STAFF RECOMMENDATION

**3925 Cambridge Avenue
December 19, 2018**

Application: Partial Demolition; New Construction—Addition; Setback Determination

Figure 2: Demolition plan, November 2018 Submittal

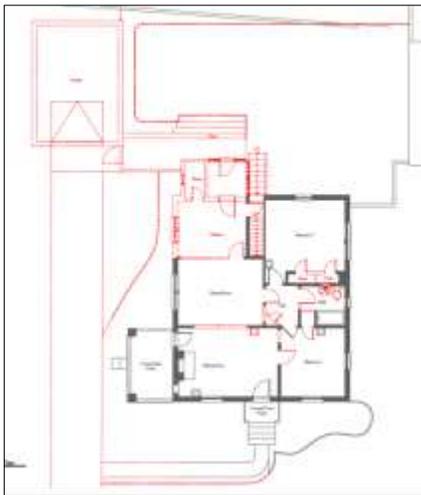
Demolition: The proposed addition would “wrap” the rear-left corner of the house, and involves demolishing portions of the house at the rear and left side of the original building. In general, additions are most appropriate at the rear or in certain situations they may be appropriate on the side, but wrapping a corner is generally not appropriate because doing so requires more demolition of the original building and makes the addition less reversible.

Staff finds that the circumstances of this lot, however, could justify an addition wrapping the corner. Because the lot is eighty feet (80') wide and only one hundred, five feet (105') deep, the buildable area is more to the side than the rear, unlike the typical situation for most houses. Because of the atypical lot dimensions at 3925 Cambridge Avenue, Staff finds that this partial demolition at the corner would meet section III.B.2 of the guidelines for appropriate demolition,

DATE OF ISSUANCE:
24 October 2018
REVISED: 03 December 2018
EXISTING SITE PLAN

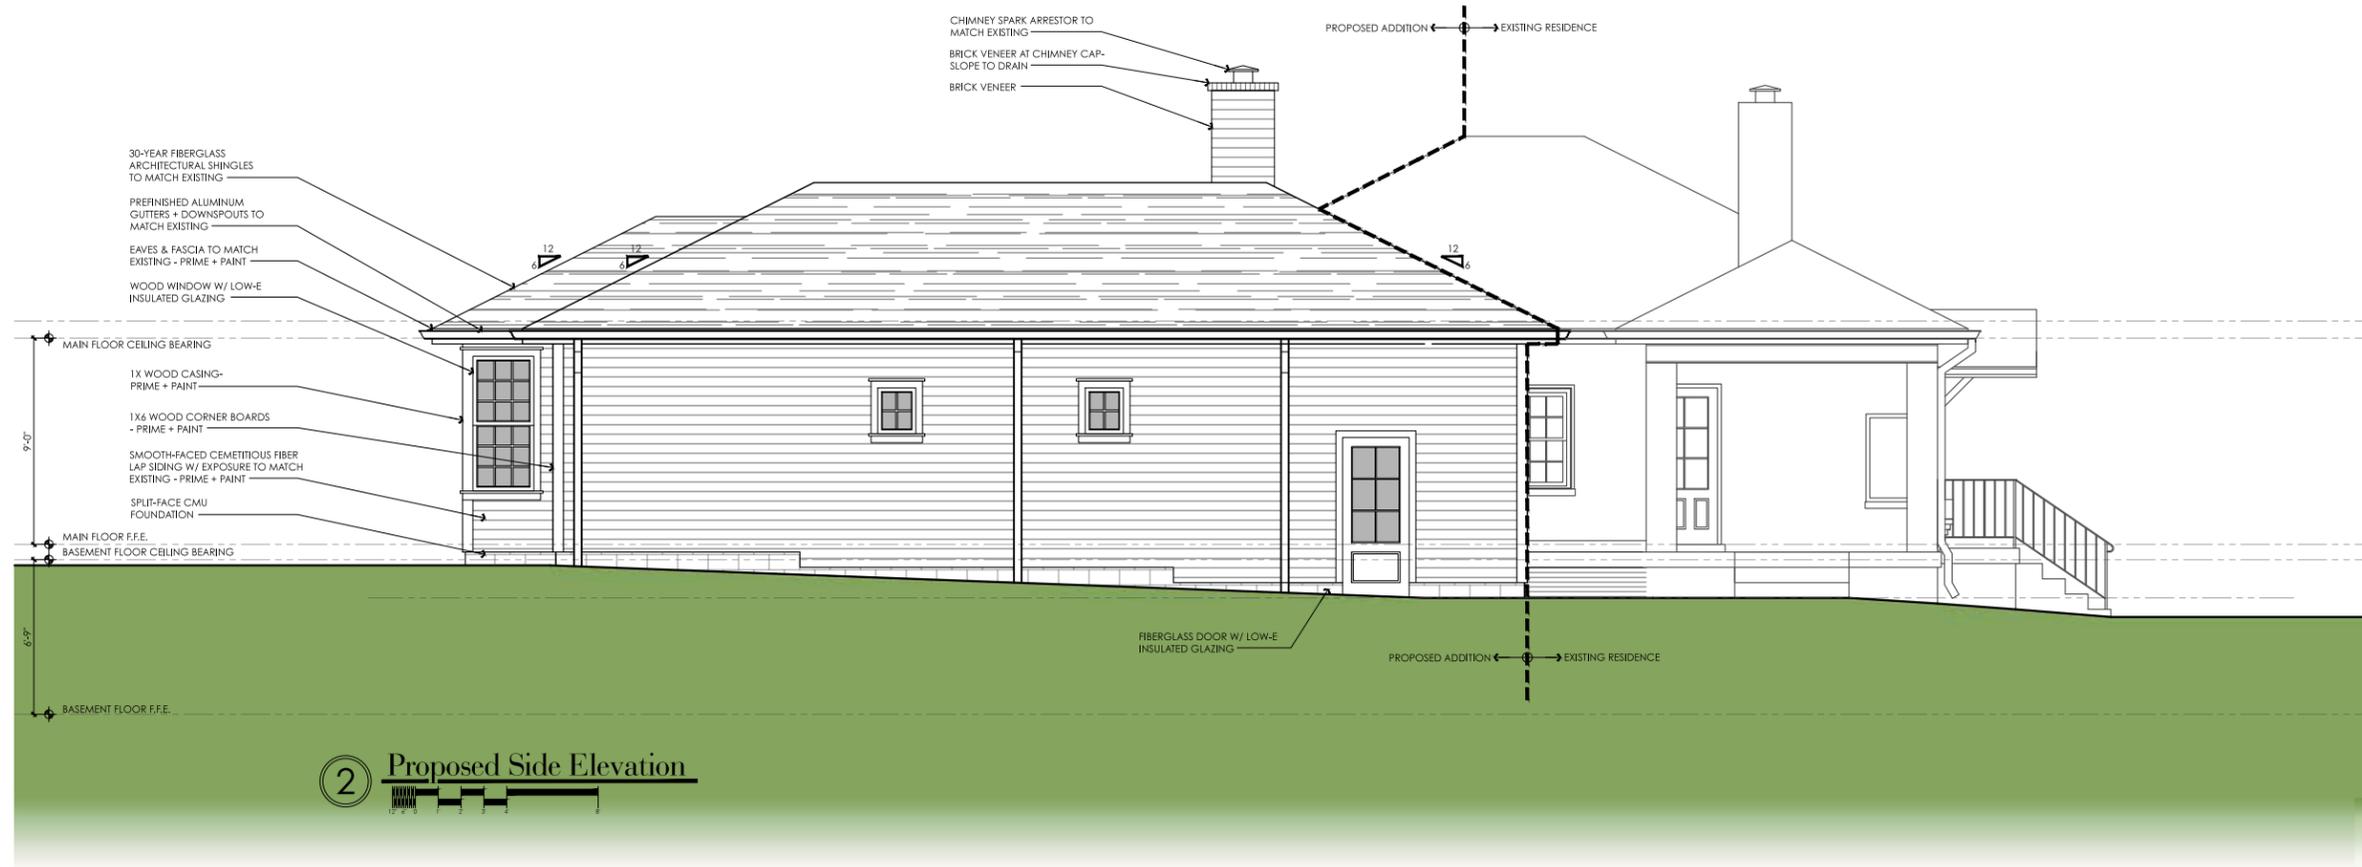
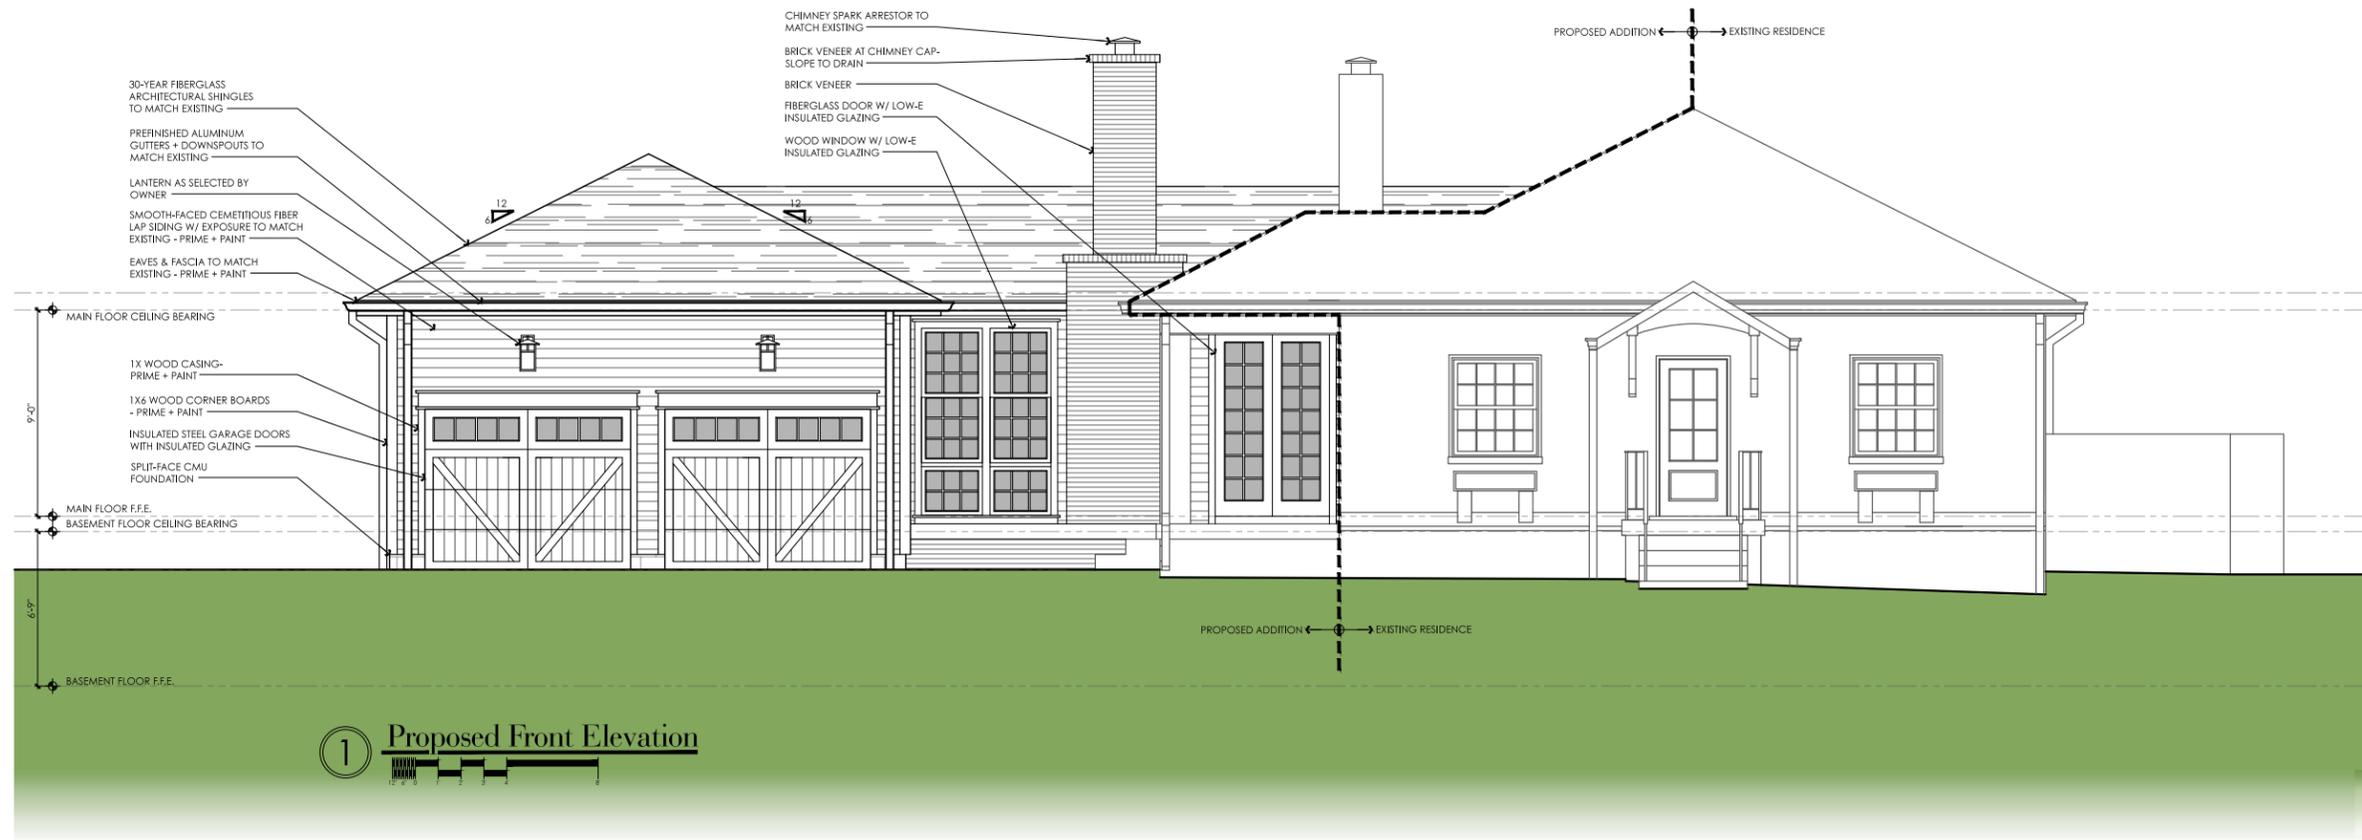
Setback & Rhythm of Spacing: The lot is one hundred, five feet (105’) deep on the right and one hundred, eleven feet (111’) on the left and the house is located only thirty-two feet (32’) from the rear property line. With a standard rear setback requirement of twenty feet (20’), the buildable area behind the house would be limited to approximately twelve feet (12’) deep.

The applicant is proposing an addition that would extend the depth of the house by twenty-eight feet (28’), coming to five feet (5’) of the rear property line. The Commission has the authority to determine setbacks when doing so is appropriate for the historic context, and given the size of the lot. Staff finds that the reduction of the rear setback may be appropriate but is concerned with the amount of reduction for a lot with no rear alley. In the past, the Commission has reduced the rear setback to ten feet (10’) and sometimes less in cases where the property backed up to a railroad or high-density development. In this case, the property backs up to the rear of two properties with the same residential use and zoning, have developed in the same manner, and that are also located in the Cherokee Park Neighborhood Conservation Zoning Overlay. The lots behind are also less than the typical depth of one-hundred and fifty square feet (150’) and would also have minimal opportunity for rear additions. Because the circumstances between 3925 Cambridge Avenue and 4020 and 4018 Aberdeen Road are similar, the same rear setback approved here would be appropriate for all three lots. The result could be a large stretch of area with just ten feet (10’) between the rear walls of buildings in a situation where they would normally have at least forty feet (40’). For this reason, Staff does not recommend that the rear setback is reduced to be less than ten feet (10’).

Appurtenances & Utilities: There is currently a driveway to the left side of the house leading to an existing garage at the rear of the lot. The site plan indicates that the existing drive will be widened near the garage entrance. There are no alleys in the Cherokee Park neighborhood, driveways are common. Two walkways will be added. One will lead

With a condition that the rear setback is reduced to be no less than ten feet (10’), Staff finds that the proposed addition would meet section II.B.1.c of the design guidelines.

1. The rear setback shall be a minimum of ten feet (10'); and
2. The window and door selections and paving material shall be administratively approved.

DATE OF ISSUANCE:
24 October 2018
REVISED: 03 December 2018
PROPOSED ELEVATIONS

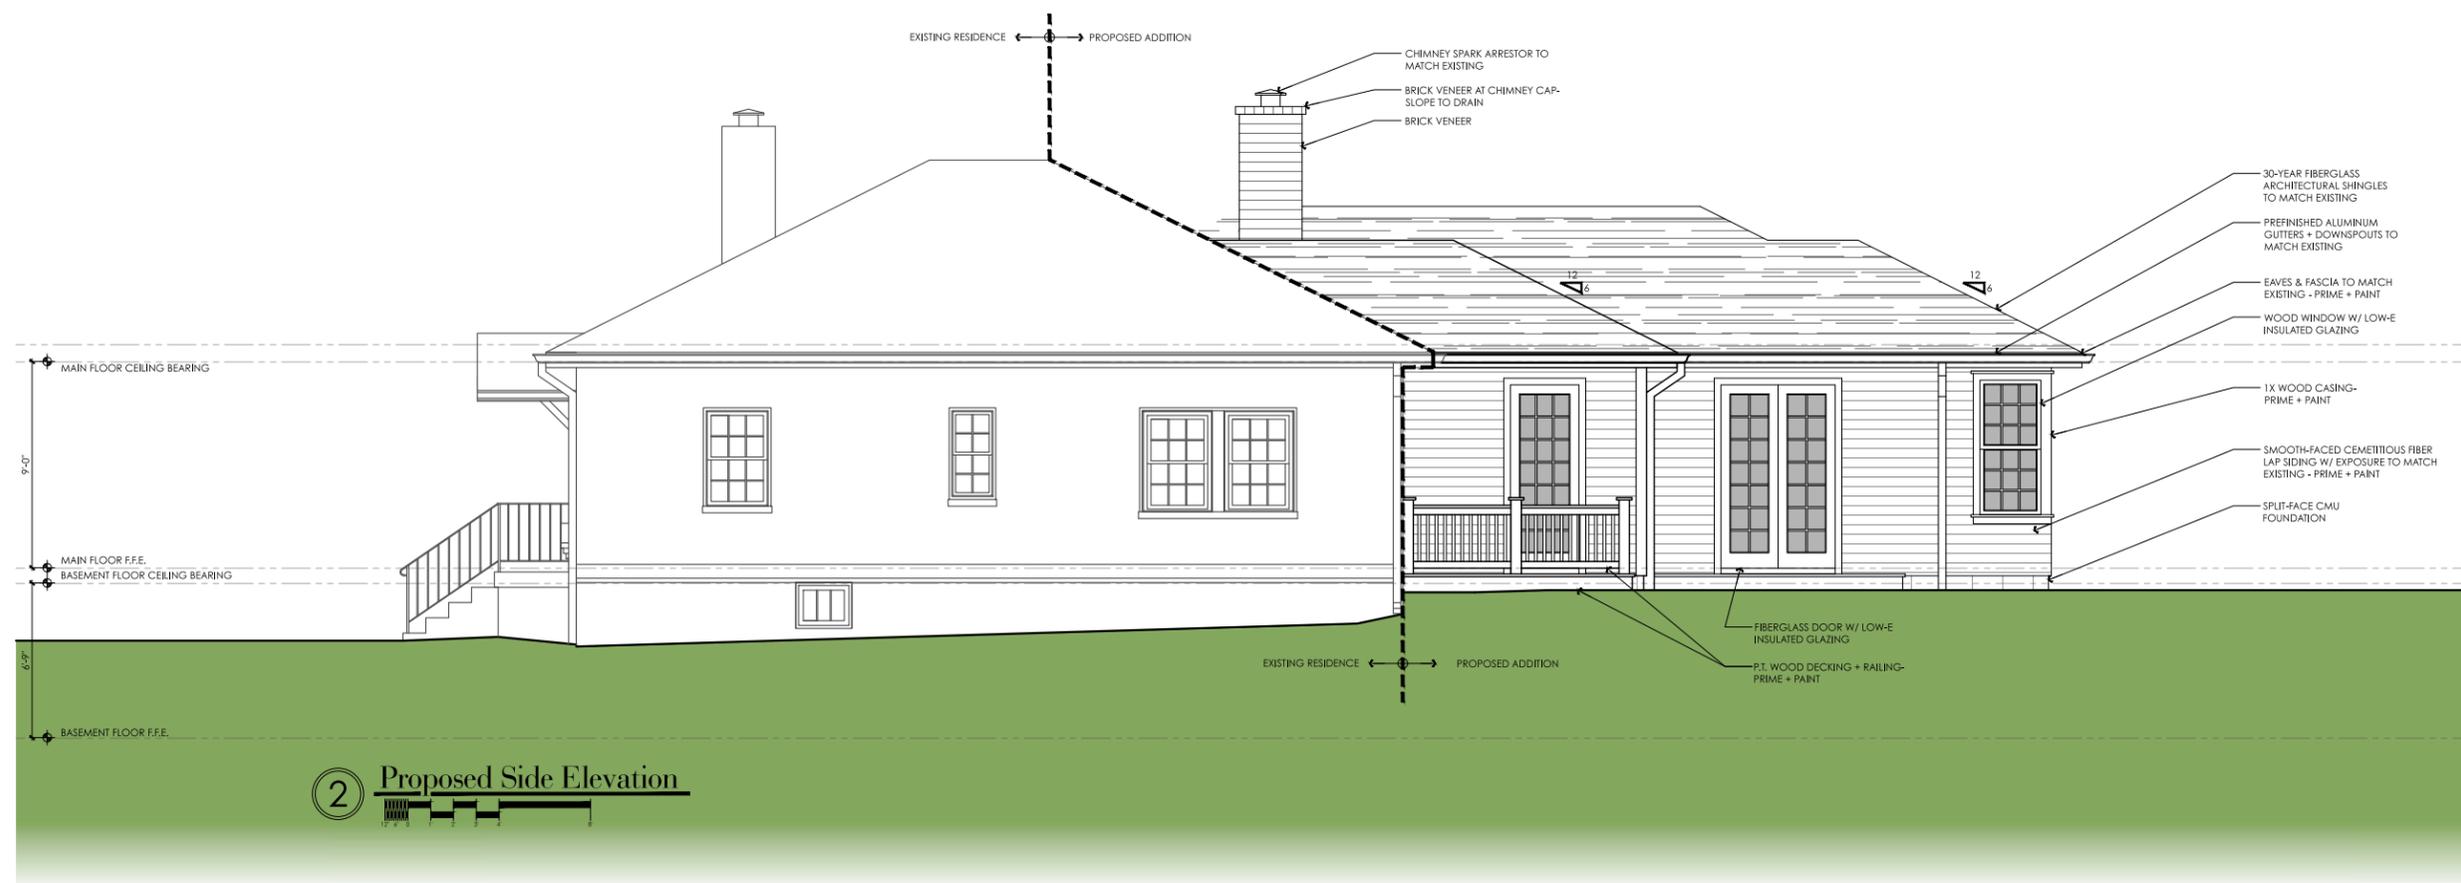
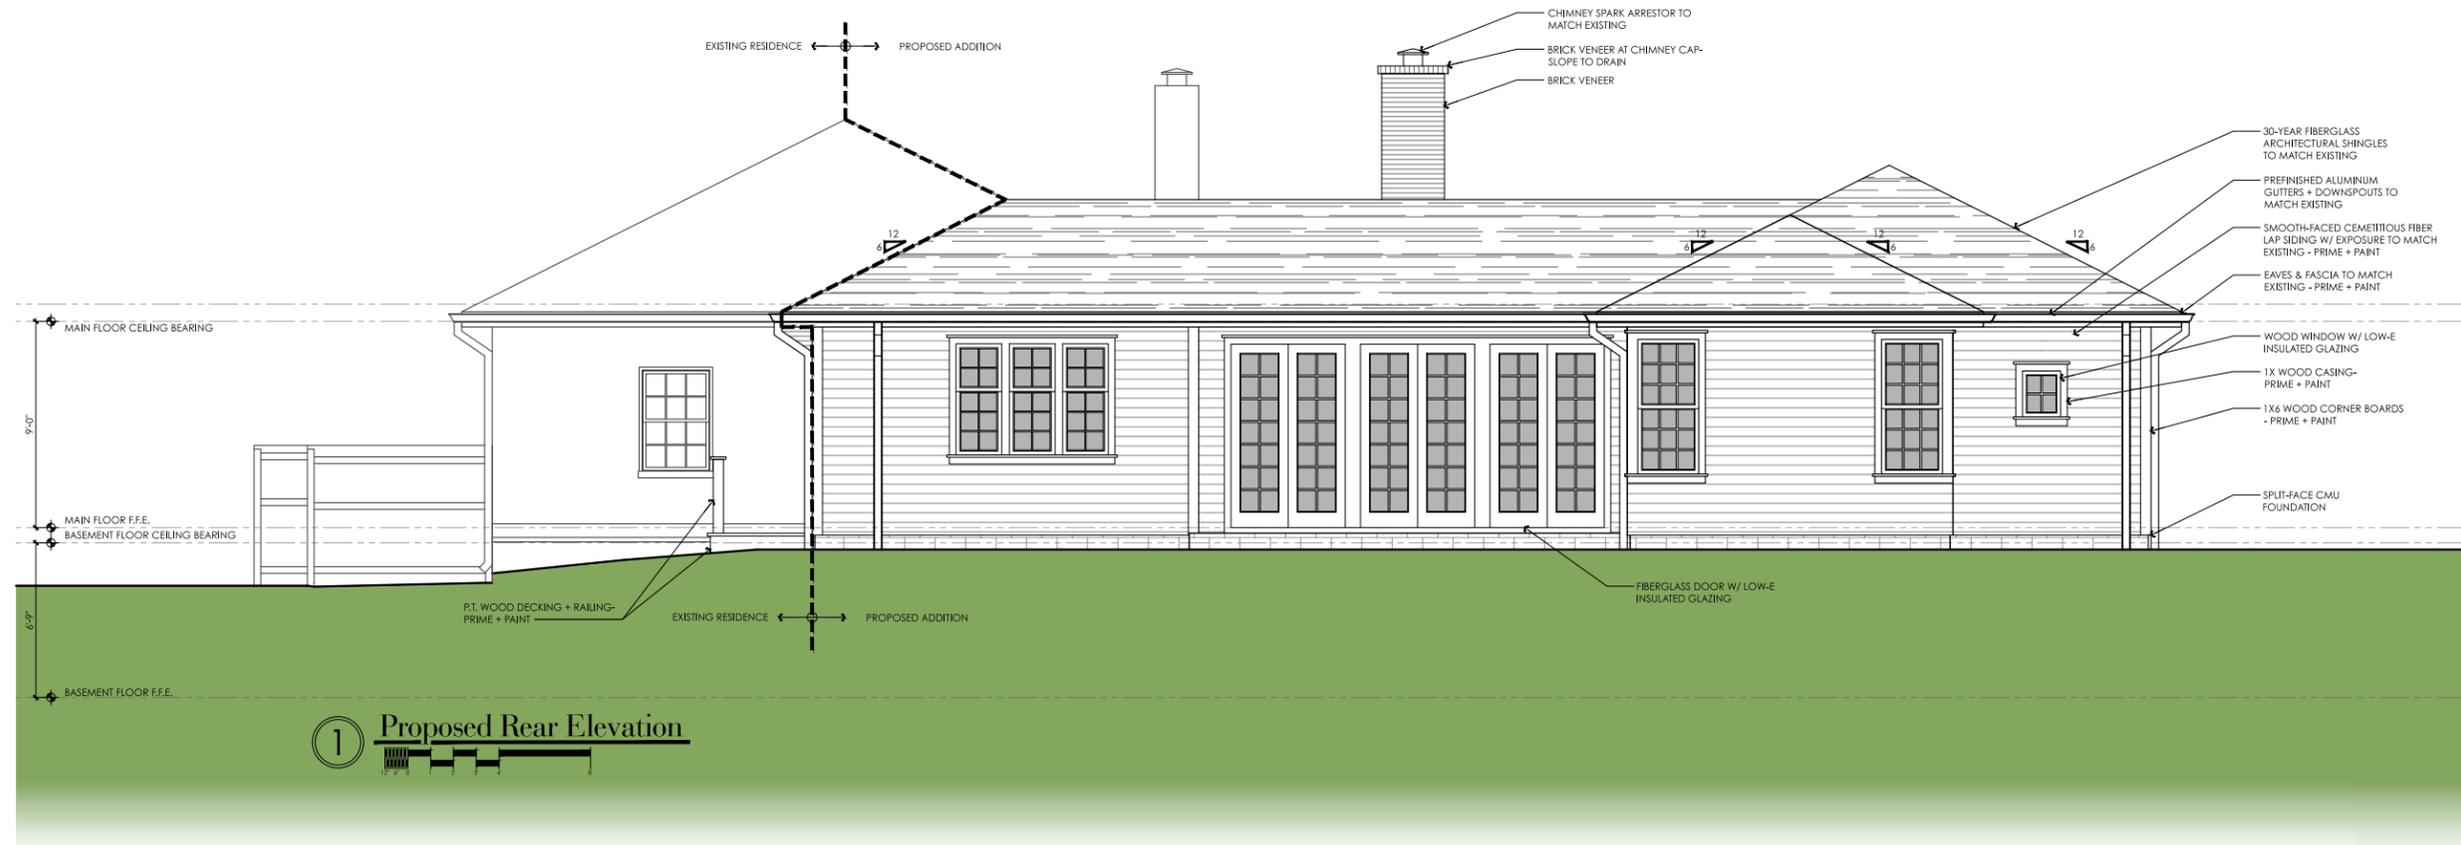
Height & Scale: The addition will have two components, both one-story tall. The primary component will consist of a garage and master suite, connected to the historic house by a central "hyphen" component containing a great room. The garage/master component will have a hipped roof with a ridge peak two feet (2') lower than the peak of the historic house's roof. The hyphen's roof will tie in one foot, six inches (1'-6") below the ridge of the garage and three feet (3') lower than the peak of the house. The eaves of both components will align with the eaves of the historic house.

The hyphen component of the addition will attach to the left side of the house twenty-five feet (25') back from the front and will be nineteen feet (19') wide, extending eleven feet (11') past the house's eight foot (8') deep side porch. The garage component will extend another twenty-three feet (23') wide, stepping forward seven feet (7') from the hyphen up to the midpoint of the house. The width of the addition, thirty-four feet (34') wide from the edge of the porch will be nearly equal to that that of the thirty-nine foot (39') wide historic house. The left side of the garage component will be forty-two feet (42') deep, six feet (6') deeper than the historic house.

Roof form: The roof of the addition will be hipped on the garage components with a 6:12 pitch, and a matching pitch on the hyphen. These roof forms and pitches match the hipped roof of the historic house. Staff finds that the roof forms of the addition are compatible with the historic house and the project would meet section II.B.1.e of the design guidelines.

Proportion and Rhythm of Openings: The windows on the proposed addition are vertically oriented and, with the exception of three square windows on the left side of the garage, are generally twice as tall as they are wide or taller. These proportions are compatible with the proportions of openings on the historic house. There are no large expanses of wall space without a window or door opening. Staff finds the project’s proportion and rhythm of openings to meet section II.B.1.g of the design guidelines.
